SUBJECT: SUMMARY OF MEETING HELD ON NOVEMBER 20, 2002, WITH ROCHESTER GAS AND ELECTRIC CORPORATION RE: PROPOSED LICENSE AMENDMENT REQUEST TO REVISE R. E. GINNA NUCLEAR POWER PLANT (GINNA) SAFETY LIMITS AND INSTRUMENTATION SETPOINTS (TAC NO. MB4789)

On November 20, 2002, representatives of the Rochester Gas and Electric Corporation (RG&E or licensee) met with the members of the Nuclear Regulatory Commission (NRC) staff in Rockville, Maryland. The purpose of the meeting was to discuss RG&E's proposed response to the NRC's request for additional information (RAI) dated September 27, 2002 (ADAMS Accession No. ML022200294). This RAI was related to RG&E's license amendment request dated April 9, 2002, to revise the Ginna Improved Technical Specifications (ITSs) to remove the Trip Setpoint column from Table 3.3.1-1, "Reactor Trip System Instrumentation," and replace it with a column designated "Allowable Values." The amendment also proposed that the Trip Setpoint column in Table 3.3.2-1, "Engineered Safety Feature Actuation System Instrumentation," be deleted. Meeting slides were used to address each RAI question for the purpose of gaining NRC staff feedback on the level of detail requir

Typical PWR Plant Schematic

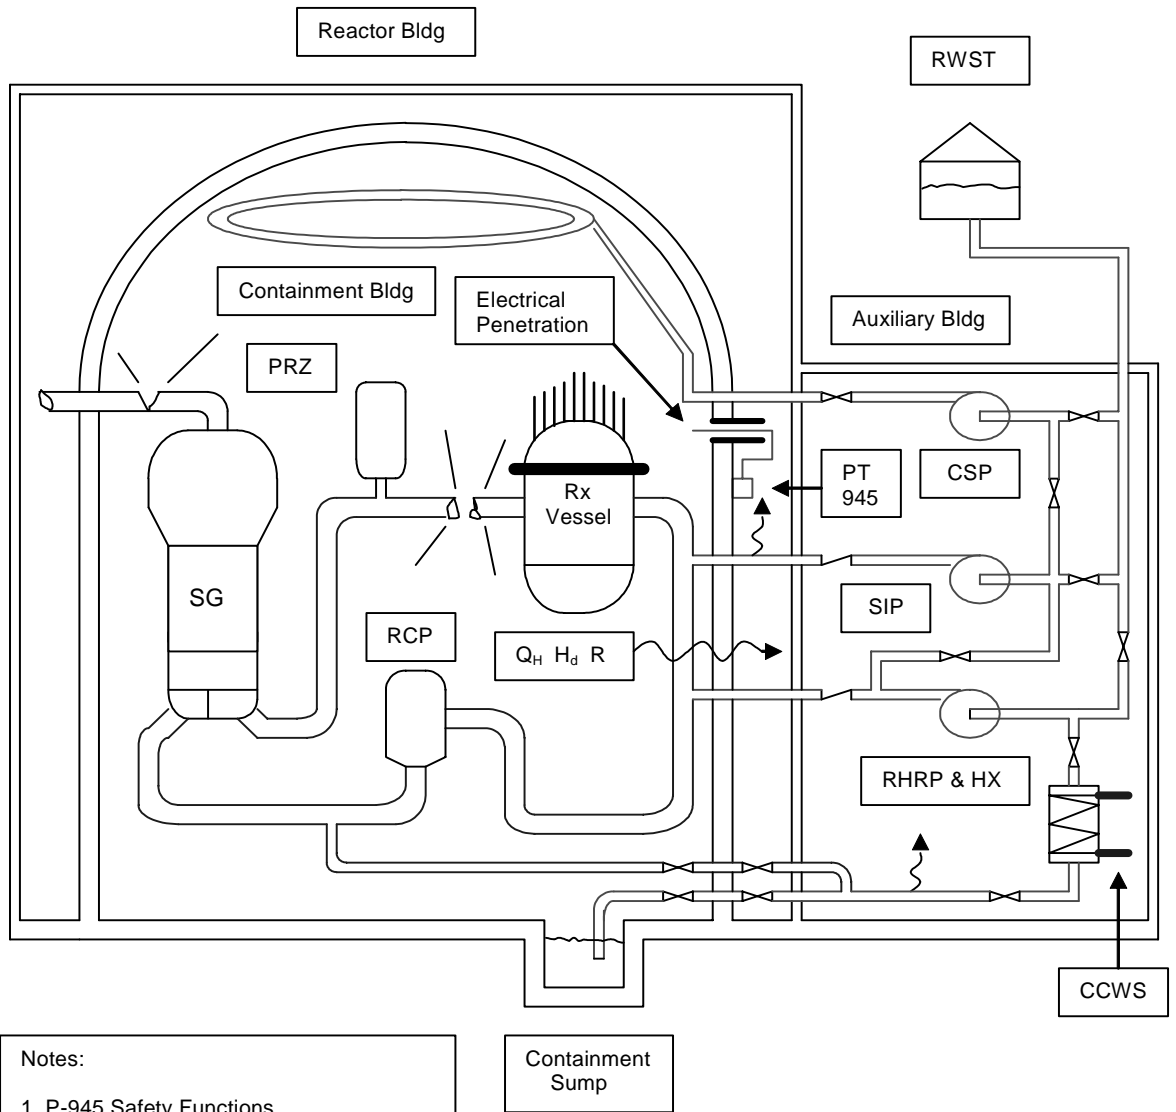
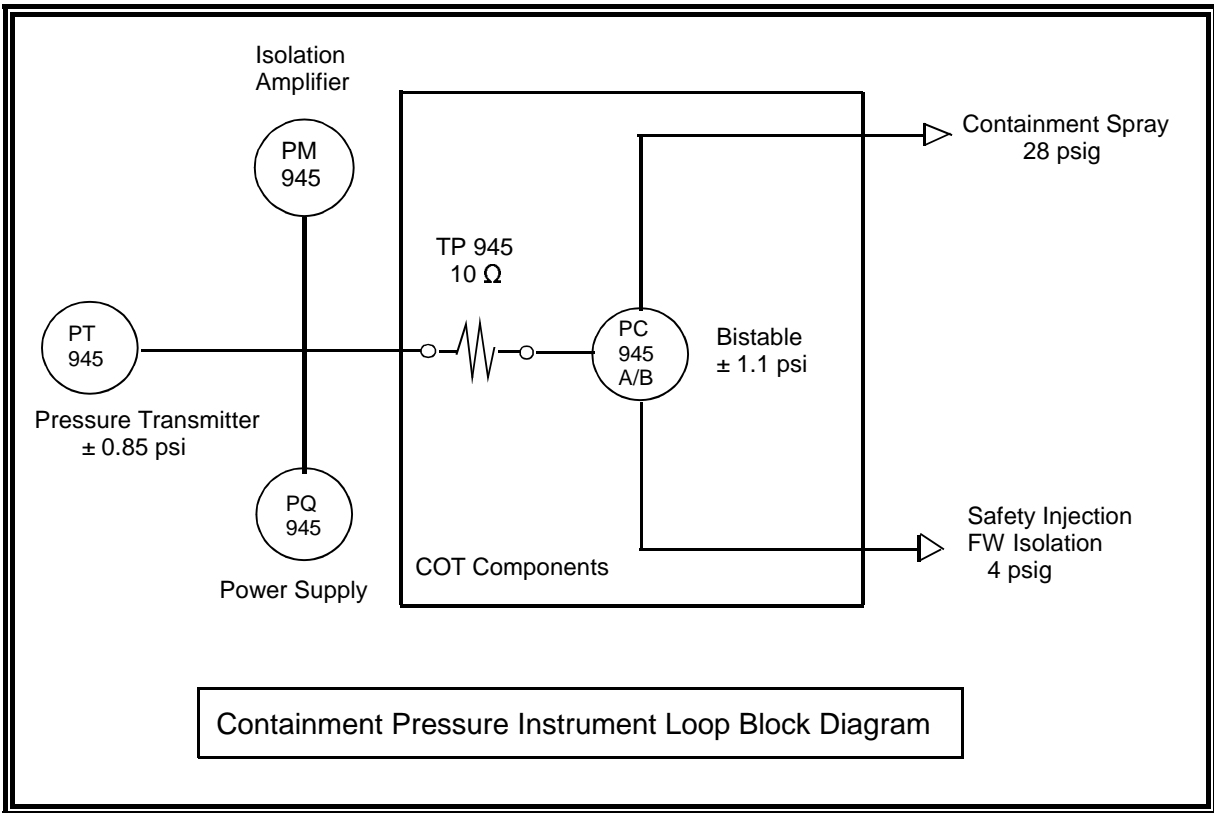
1. P-945 Safety Functions

- a. Initiate SI at 4 psi
- b. Initiate FW isolation at 4 psi
- c. Initiate CS at 28 psi
- d. Post Accident Monitoring

2. PT-945

Model – Foxboro N-E11GM-HIB1-BE
 PE - diaphragm
 PE_U - N/A

3. P-945 Uncertainty Calculations

Per RG&E $TLU_A = TLU_N$
 Per ISA $TLU_A > TLU_N$
 (conservatively account for possible environmental effects (T, R, H_d) due to HELB inside containment)

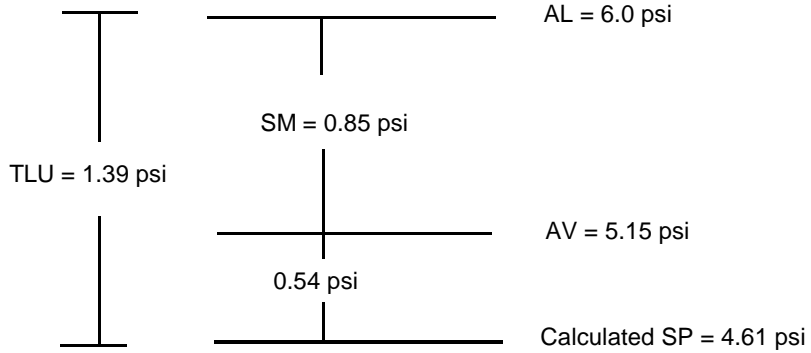
- B. In practice the complete instrument loop is not tested during surveillance testing. The reference signal is applied only to the bistable/resistor combination and the setpoint deviation measured. This partial test of the instrument loop is called the Channel Operability Test (COT) and is use to verify that the uncertainties associated with the bistable setpoint is within its normal operating range (± 1.1 psi). The COT is performed on a quarterly basis. The required safety margin for the COT is defined as:

$$SM_{cot} = \pm \sqrt{TLU_A^2 - U_{cot}^2}$$

This equation for the COT safety margin accounts for all uncertainties due to design-basis event effects, if applicable, plus those components not tested during the COT (pressure transmitter, power supply, isolation amplifier, etc),

For example, RG&E claims that PT-945 is not located in a harsh environment and, therefore, $TLU_A = TLU_N$. For these conditions the COT safety margin is equal to:

$$SM_{cot} = \pm \sqrt{TLU_N^2 - U_{cot}^2}$$

$$SM_{cot} = \pm \sqrt{1.39^2 - 1.1^2} = \pm 0.85 \text{ psi}$$

2. ALLOWABLE VALUE

The allowable value is equal to the Analytical Limit (AL) minus the Required Safety Margin (SM_{cot}):

$$AV_{ISA} = AL - SM_{cot} = 6.0 - 0.85 = 5.15 \text{ psi}$$

SUMMARY

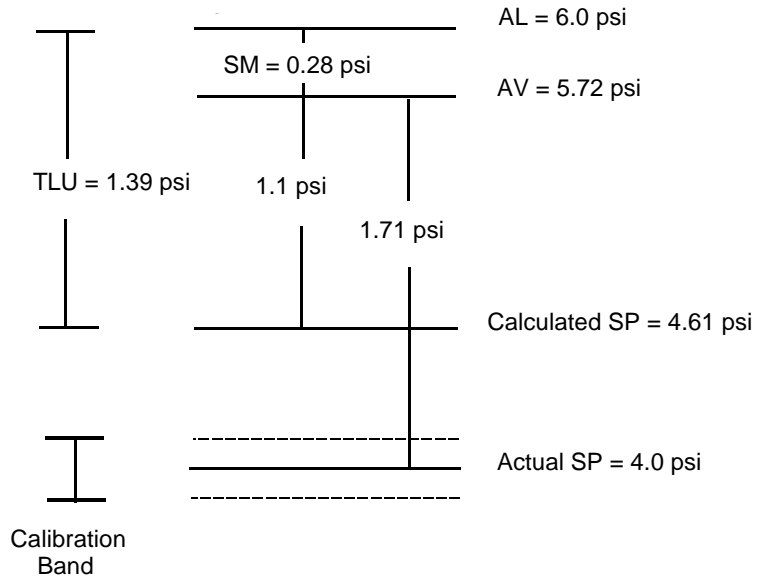
Method 1 (ANSI / ISA - RP67.04)

Method 2 (RG&E)

PROPOSED SOLUTION

Method 3
